VESSEL'S NAME Steel S.S. "WILLEMSPLEIN" Rpt. Rot. No. 23824

Nature of Survey 2nd. S.S. No. 3.

THICKNESSES OF PLATING ascertained by drilling, and comparison of same with the original thicknesses.

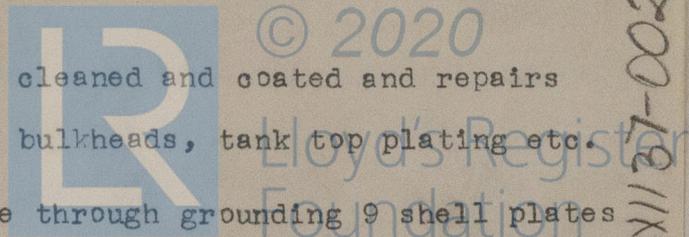
The class is subject to indented bottom plating plates B4 and C4 starboard side being dealt with at the Owners' convenience.
